Jean Fraser - Planner
City of Portland
Planning & Urban Development Department
389 Congress Street
Portland, ME 04101

January 17, 2014

Subject: Munjoy Heights
 Final Level III Site Plan – Conditions of Approval
 Comment Response Letter

DRAWING NO. **C-20**

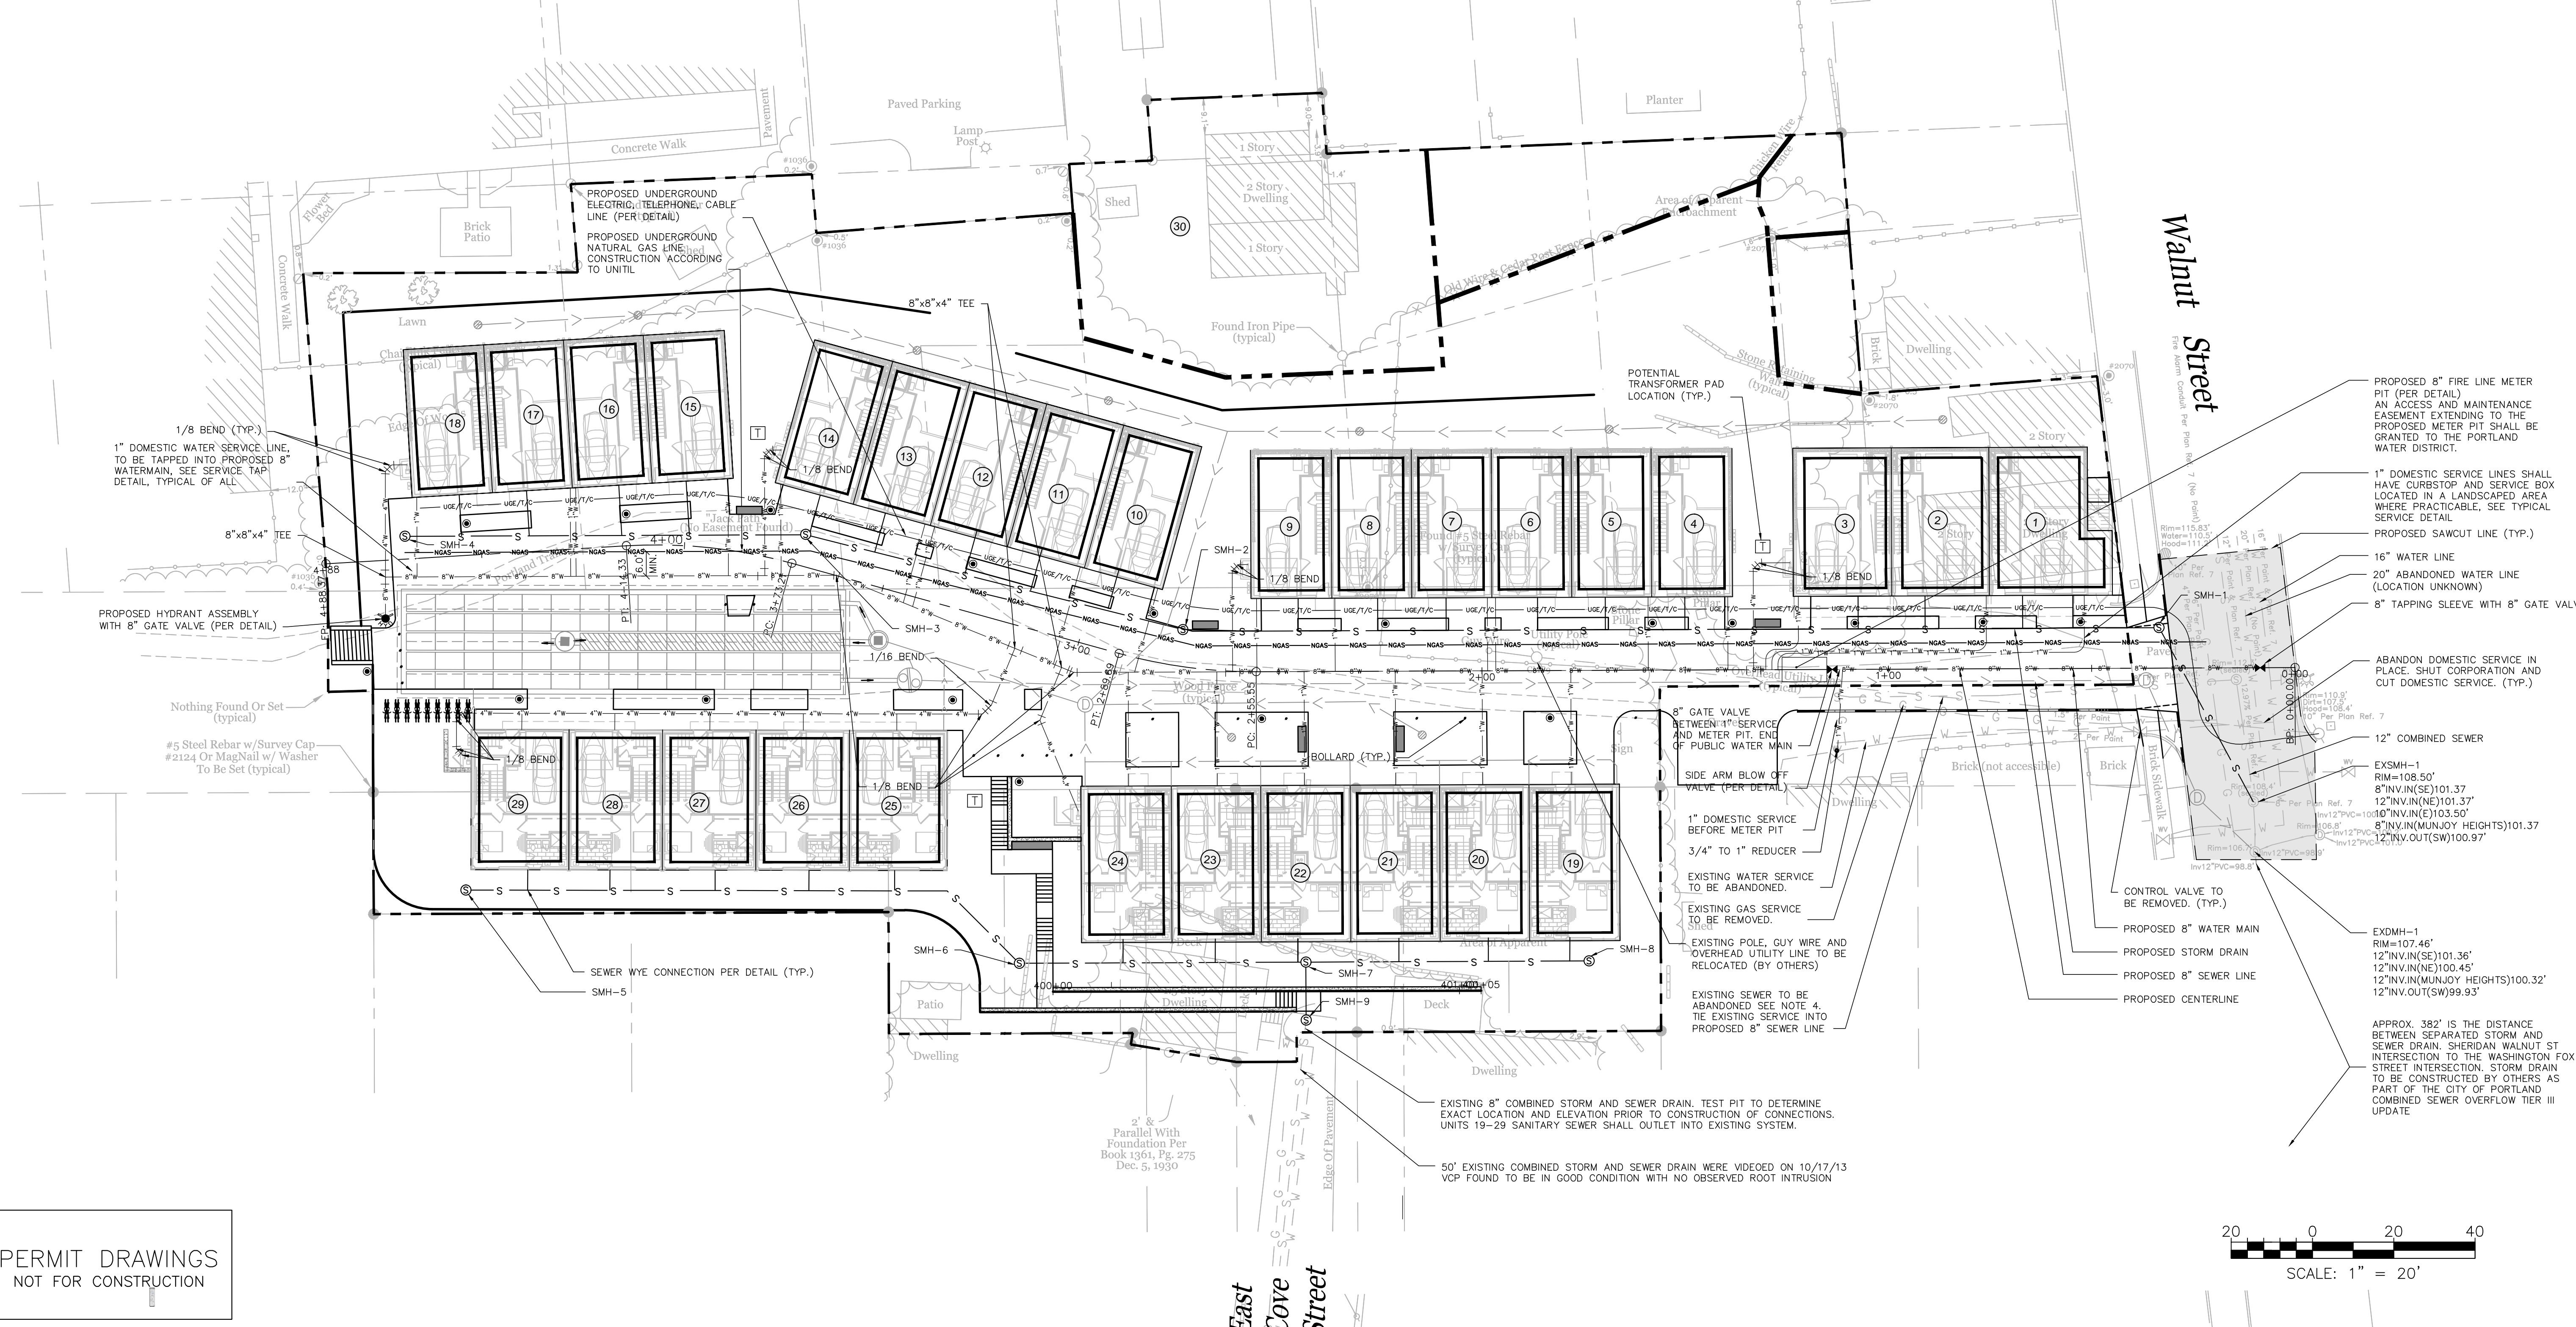
- 13) *Comment mostly addressed; note that Unit #20 is missing a sewer service connection on sheet C-20.*

Response – A sewer service was added to Unit #20 on Sheet C-20. Thank-you.

DRAWING NO. **C-30**

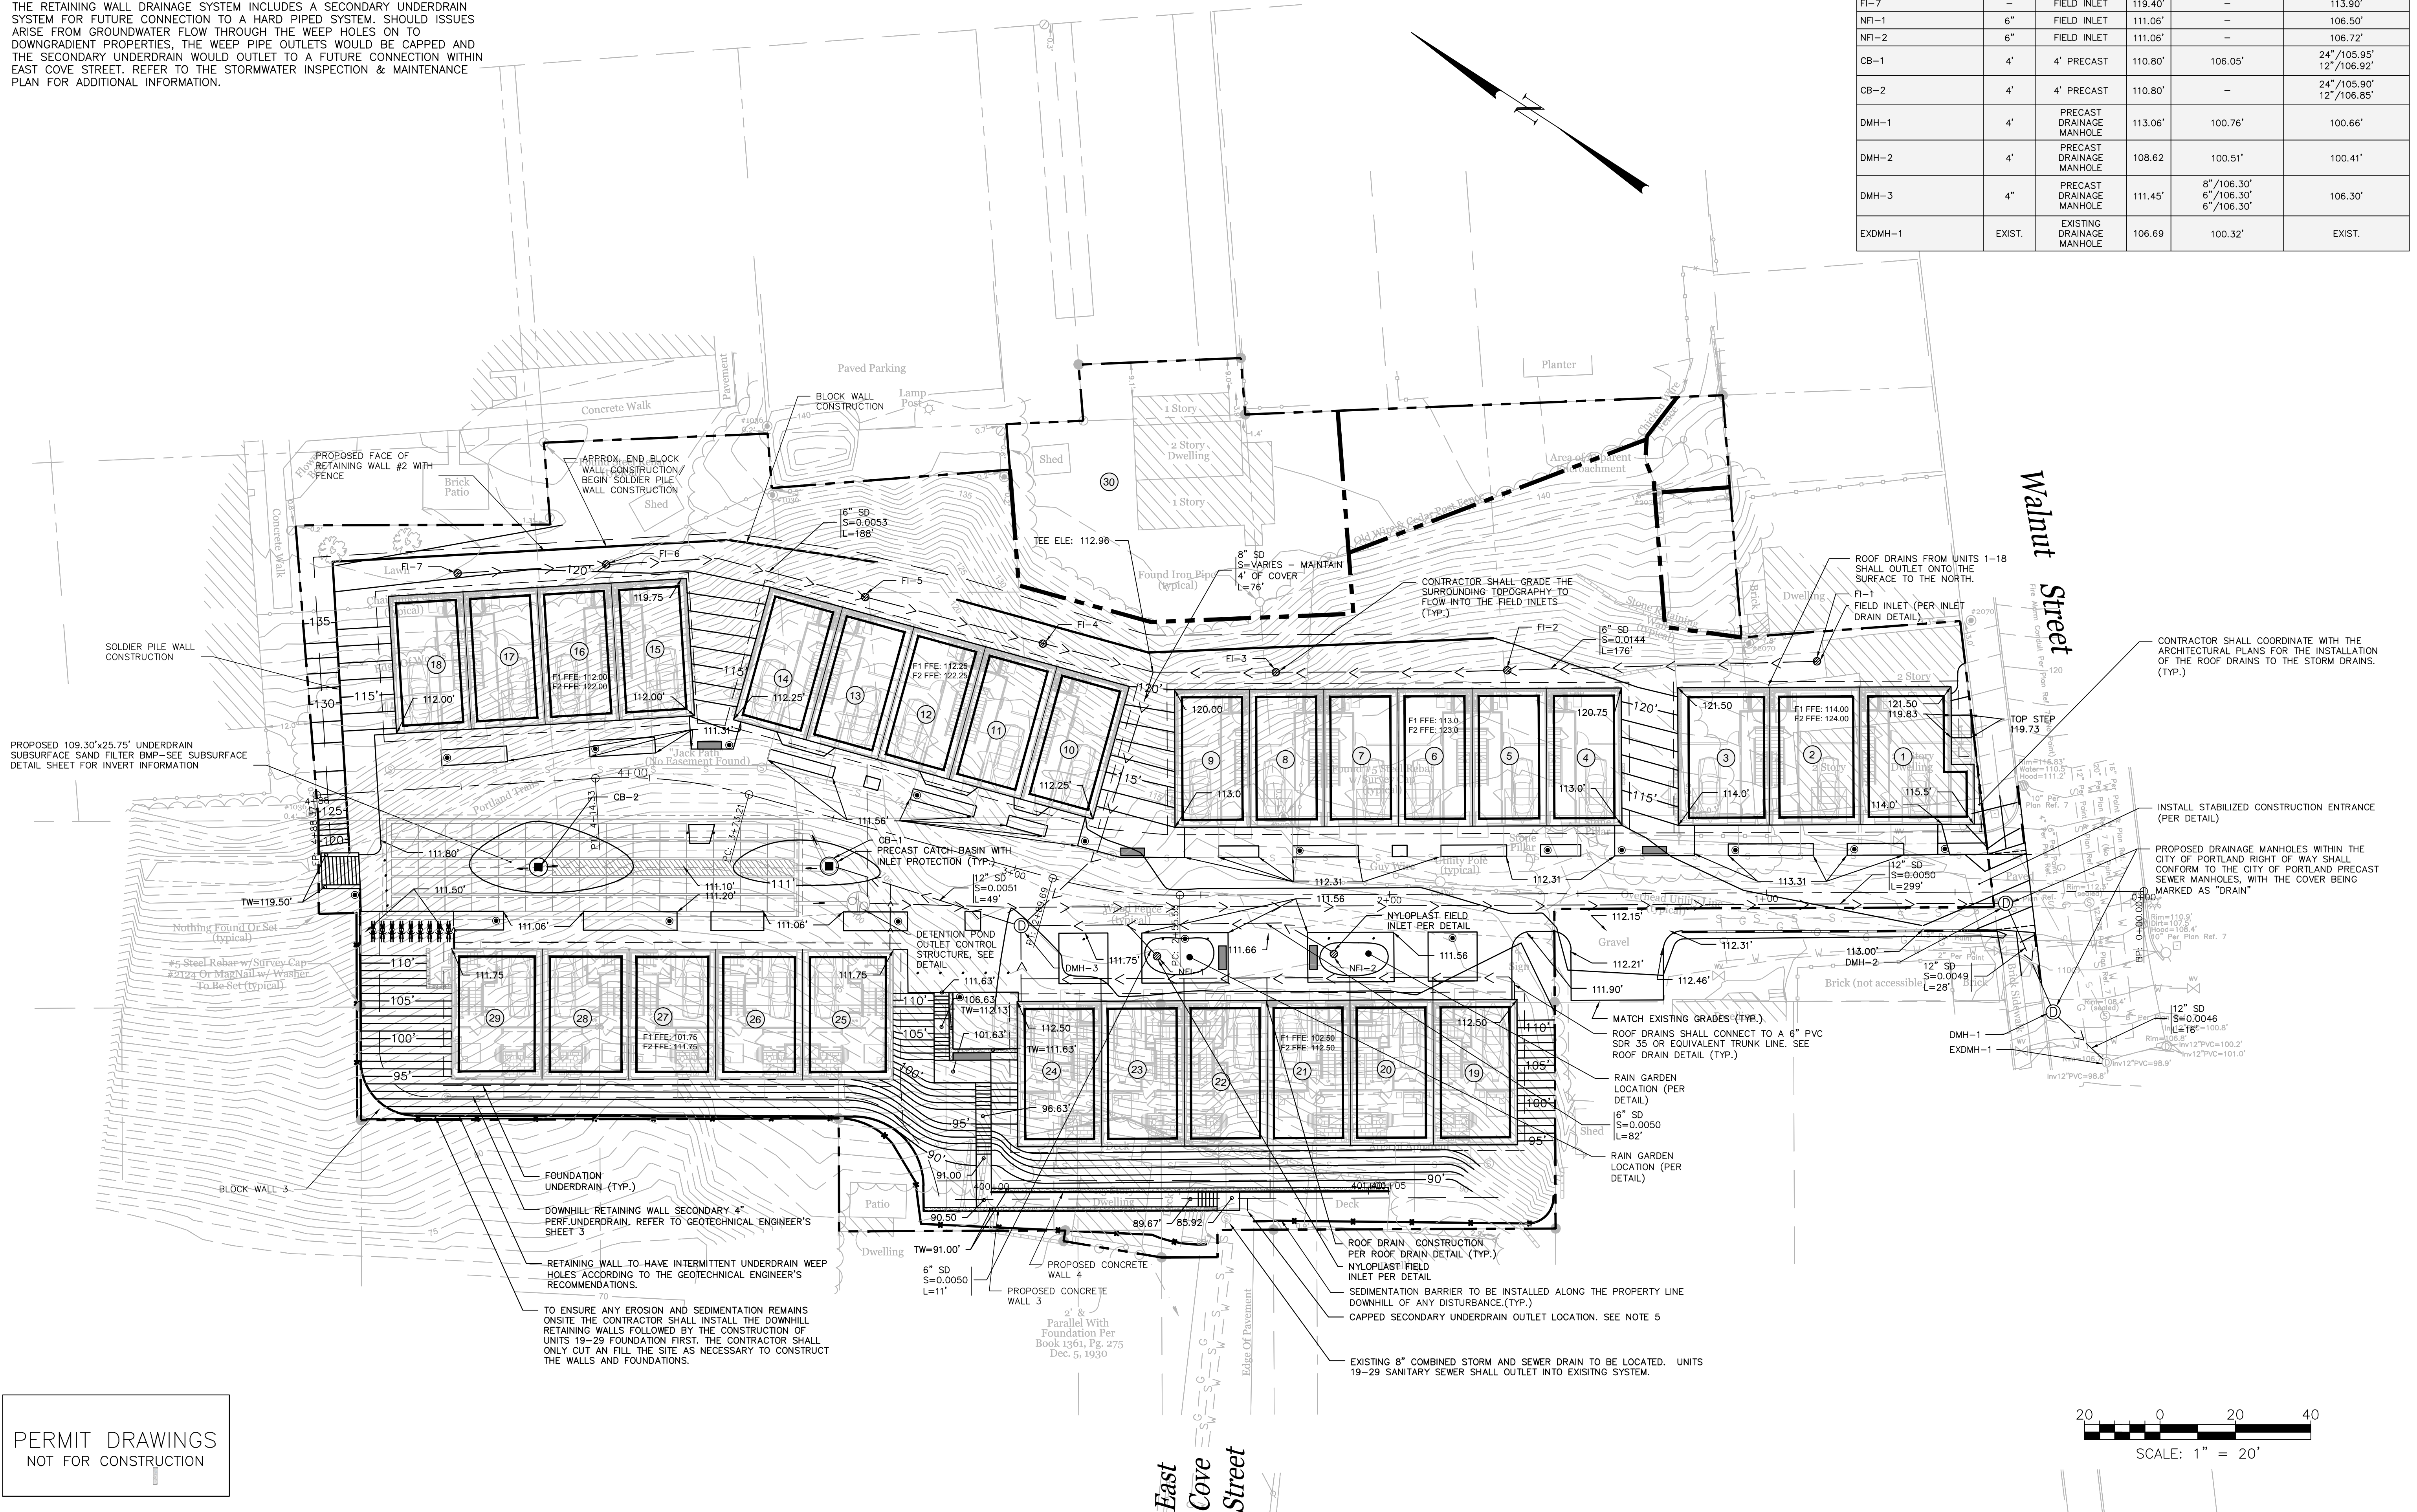
- 1) a), b) & c) (i.)(ii.)(iii.) – Comments adequately addressed.
- 2) a), b) & c) – Comments adequately addressed.
- d) Sheet C-30: The access/diversion structure labeled CB-1 has two outlets, a 12” pipe and a 24” pipe. The 24” pipe connects to the Isolator Row, whereas the 12” pipe appears to connect to an adjacent standard chamber. Please clarify the intent of 12” pipe, along with the invert elevation. Because the Isolator Row is intended to remove sediment and debris from the stormwater flow, we would not anticipate that the 12” pipe invert elevation would be set the same as the 24” pipe invert elevation. If the 12” pipe is acting as a high-flow outlet, we would anticipate that the invert elevation of this pipe would be set higher than the 24” pipe.

- 18) *The Applicant has noted that a revised C-30 drawing will be provided to address the previous review comment; we will review upon receiving the revised C-30 plan.*

19) *In general we agree with the Applicant's proposal to provide "weep holes" at the base of the wall in lieu of a direct connection to the combined sewer in East Cove Street. The Applicant should include details and notes on the plans for the weep hole outlets to ensure that they are properly stabilized and that they do not direct concentrated flow onto adjoining properties. Per discussions with City DPS, the Applicant should design the retaining wall drainage system and weep holes to allow for a future connection to a hard-piped system if issues arise from groundwater flow. Additional notes and design details should be submitted for review and approval.*

Response – The 12” pipe is acting as a high-flow outlet for CB 1 and CB 2. This has been clarified within the Drainage Control Structure Schedule on Sheet C-30.

Response – Sheet C-30 was revised to include sloped granite curb, along the driveway entrance, to redirect the stormwater away from the Rando property and towards the proposed rain gardens and USSF.

Acorn Engineering revised Sheet C-30 to include the following Note 5.

"5. The retaining wall drainage system includes a secondary underdrain system for future connection to a hard piped system. Should issues arise from groundwater flow through the weep holes on to downgradient properties, the weep pipe outlets would be capped and the secondary underdrain would outlet to a future connection within East Cove Street. Refer to the Stormwater Inspection & Maintenance Plan for additional information."

The only change from Bill Peterlein's email is that the future connection would not be to a combined sewer but to a separated system. The location of the secondary underdrain outlet was also noted on Sheet C-30. Both Sheet C-30 and the Stormwater Inspection & Maintenance Plan are included as Exhibits within the Condominium Declaration. Refer to the attached Stormwater Inspection & Maintenance Plan for additional information.

CONCRETE BRICK PAVER PROFILE
NOT TO SCALE

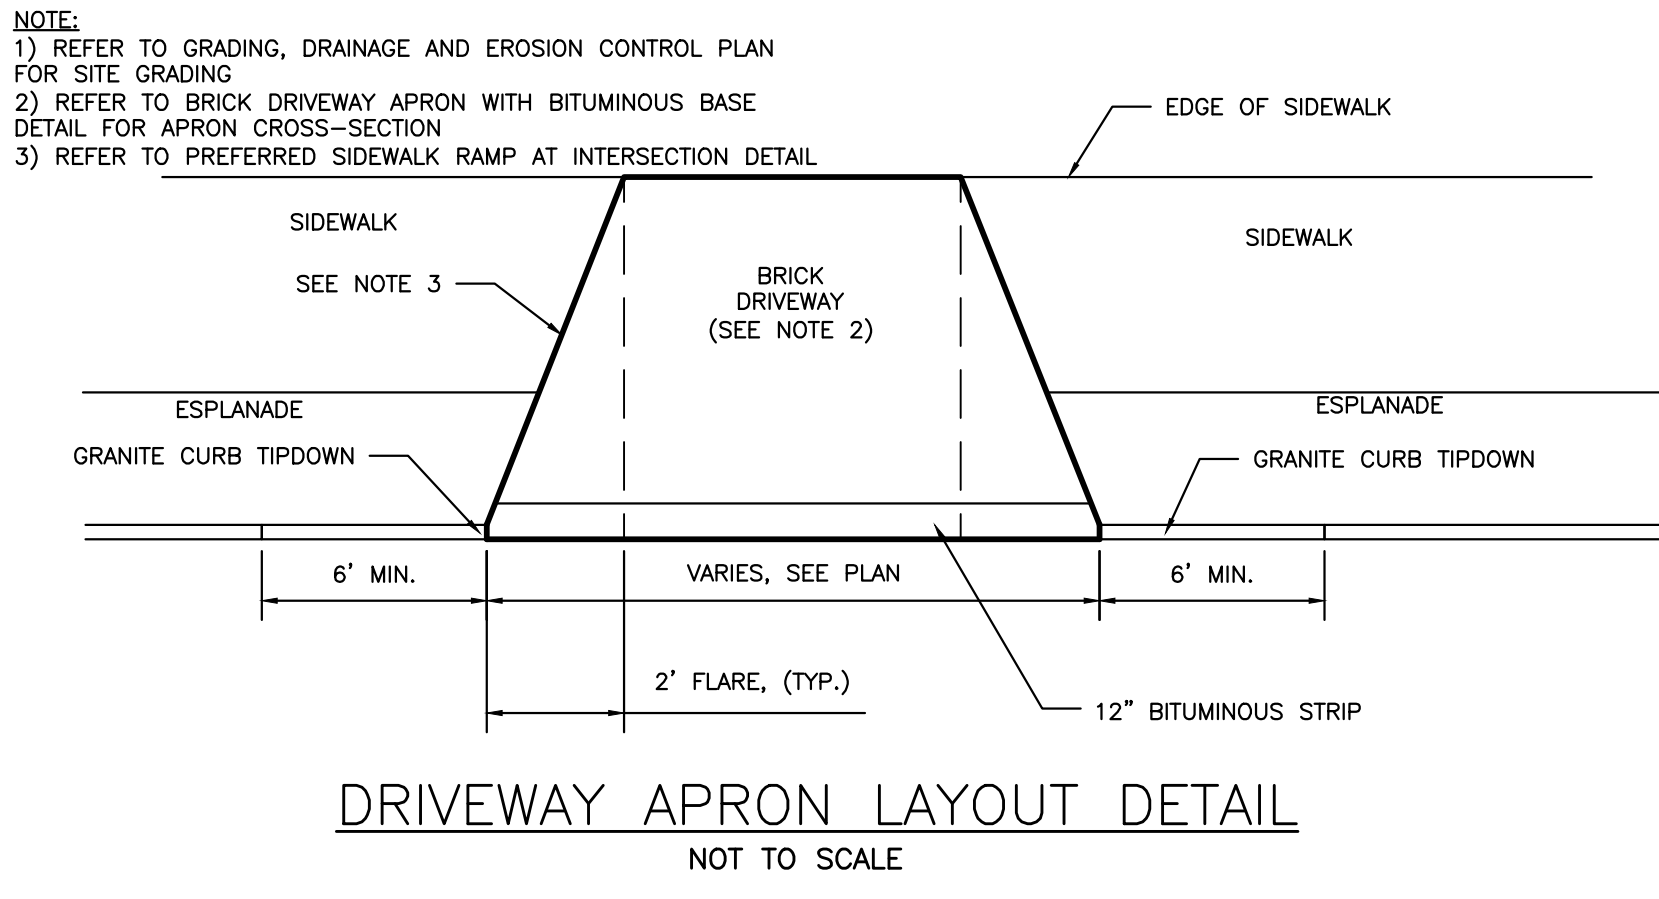
Response: The proposed driveway width was designed to be a minimum of 20 ft wide and to have the ability to withstand the weight of the Fire Department vehicles and outriggers for the entire 20 ft area of the driveway.

The geotechnical engineer has reviewed the proposed construction of the driveway (Concrete Brick Paver Detail) and recommended the minimum amount of aggregate material to support H-20 wheel loading. Please refer to the attached email from Bill Peterlein, P.E. Acorn Engineering's Concrete Brick Paver Detail exceeds the minimum aggregate depths specified.

RAIN GARDEN OR BIORETENTION CELL DETAIL
NOT TO SCALE

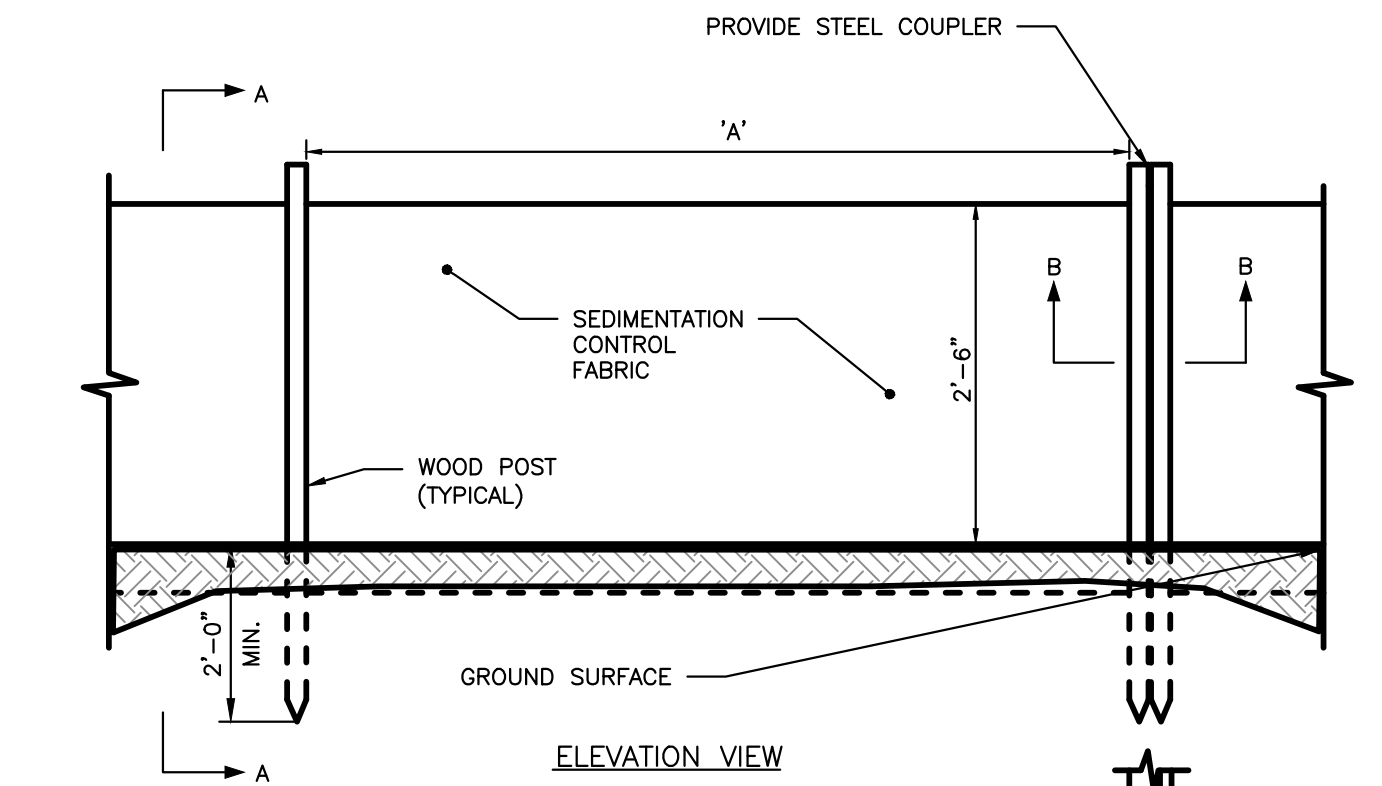
- 3) Comment adequately addressed relative to the Underdrained Subsurface Sand Filter. The plans contain additional details on two underdrained soil filters / rain gardens. It appears these systems were designed without an impermeable liner. We request review and comment on these systems by the project’s geotechnical engineer.

- 14) *Comment adequately addressed.*
 15) *Comment adequately addressed.*
 16) *Comment adequately addressed.*
 17) *The details provided for the underdrained soil filters (rain gardens) on C-42 do not provide sufficient detail at the edges of the system, where the in-slope meets the driveway/walkway pavers. The in-slope should be designed with measures to avoid erosion and under-mining of the adjacent pavers. As noted in Comment #3, the soil filters are not currently designed with an impermeable liner below the underdrain. The project geotechnical engineer should review the design to ensure that the introduction of surface water to the subsurface soils will not create geotechnical concerns.*

“I recommend that an impermeable liner be installed in the rain gardens up to at least 6 inches above the channel protection volume elevation. This measure will address the concerns of both #3 and #17 from a geotechnical perspective.”

The email is included as an attachment. The Rain Garden Detail was revised to include an impermeable liner wrapping the bottom and sides extending to 6” above the channel protection volume. Refer to Sheet C-42.

Response – Additional edge information was provided for the Rain Garden Detail on Sheet C-42. The detail specifies concrete paver edge restraints, clarifies the size of the shoulder, and provides for river stones at points of concentrated flow to mitigate the potential for erosion and under-mining of the concrete pavers. Sideslopes not protected with river stone shall be stabilized with loam, seed and erosion control blanket.
